JASiC response to TA-27-2

17th December, 2024

JAPAN AUTOMOBILE STANDARDS INTERNATIONALIZATION CENTER

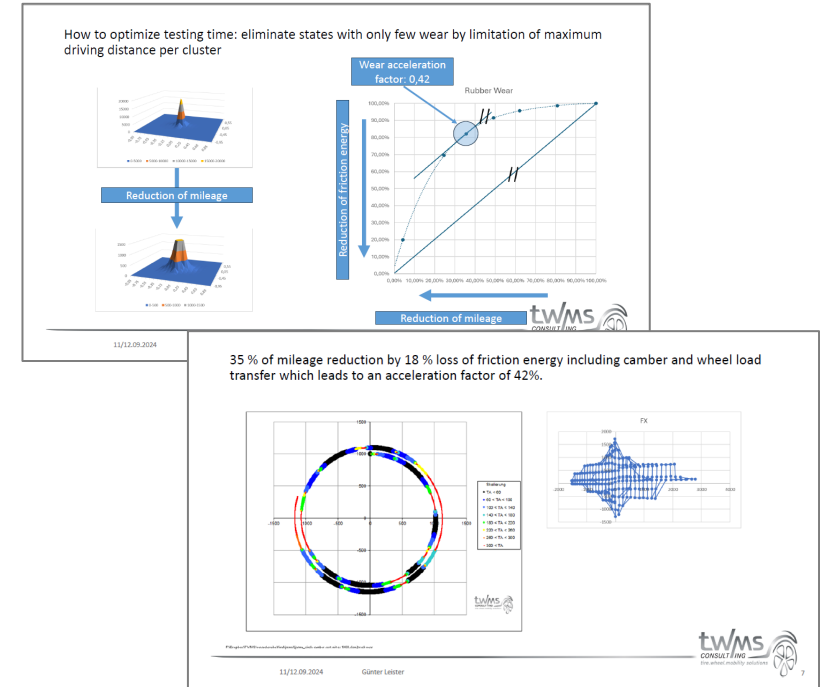
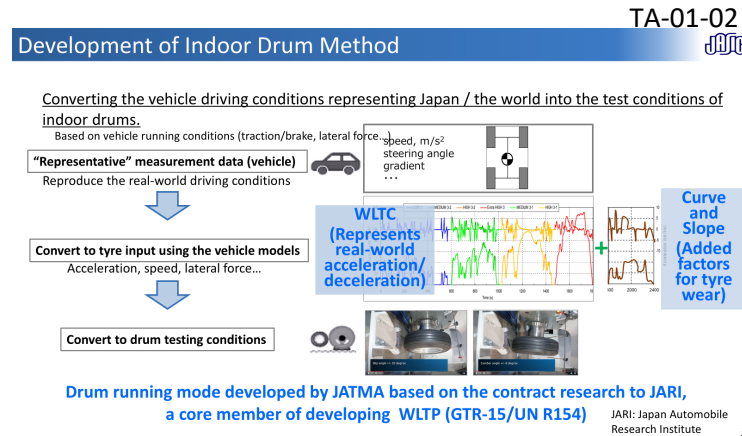
Proposal from TWMS is as follows.

- To change force input as longitudinal force faster and lateral force slower.
- To use simple vehicle model and add wheel load transfer and camber angle.
- To omit low longitudinal/lateral acceleration to improve the efficiency of the input conditions for the tyres.

- ✓ We should not forget that the concept of indoor drum method is to replicate driving in the real-world condition.

The proposal on input condition does not take real-world conditions into consideration, therefore there are technical concerns.

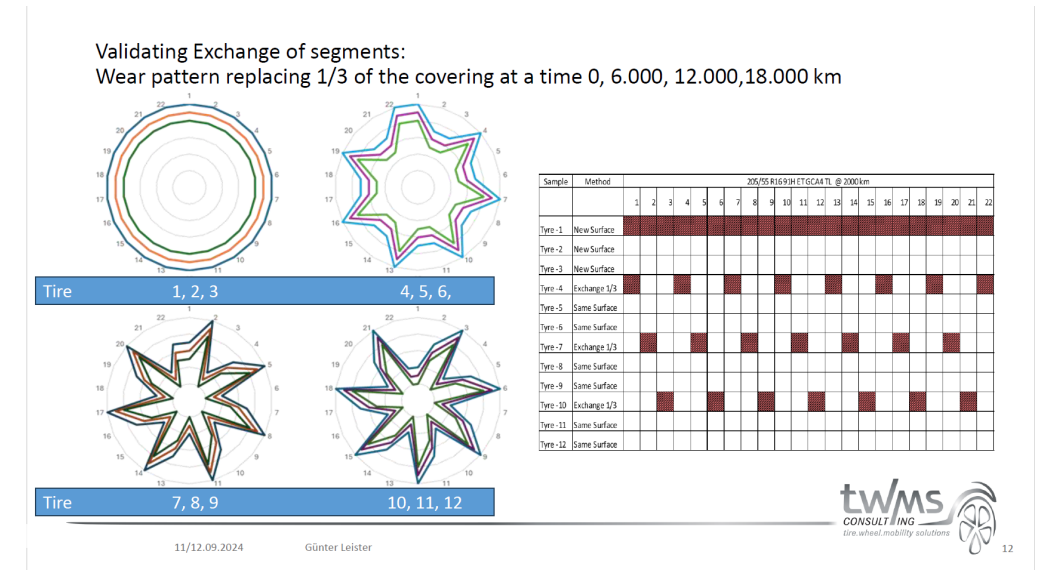
- TWMS argues that by continuing to partially replace segments of the drum, it is possible to maintain averaged drum surface condition.
- As a result, it is proposed to evaluate multiple candidate tyres with a single reference tyre.

- ✓ Theoretically, the concept of reducing the number of evaluations for reference tyres is an interesting idea.
- ✓ It is necessary to conduct additional validation tests with the appropriate tyre specs and repetitions to evaluate whether it stabilizes abrasion rate and abrasion index even without a reference tyre.
- ✓ Considering the possibility of issues arising with the road surface in a particular segment, which might require replacing that segment outside of standard procedure, it may be difficult to define this methodology as the sole method.
- ✓ JASIC is unable to conduct this validation test because it is full capacity with market assessment tests, correlation tests, and preliminary assessment tests for C2 tyres.

JASIC suggest that additional validation tests are necessary.
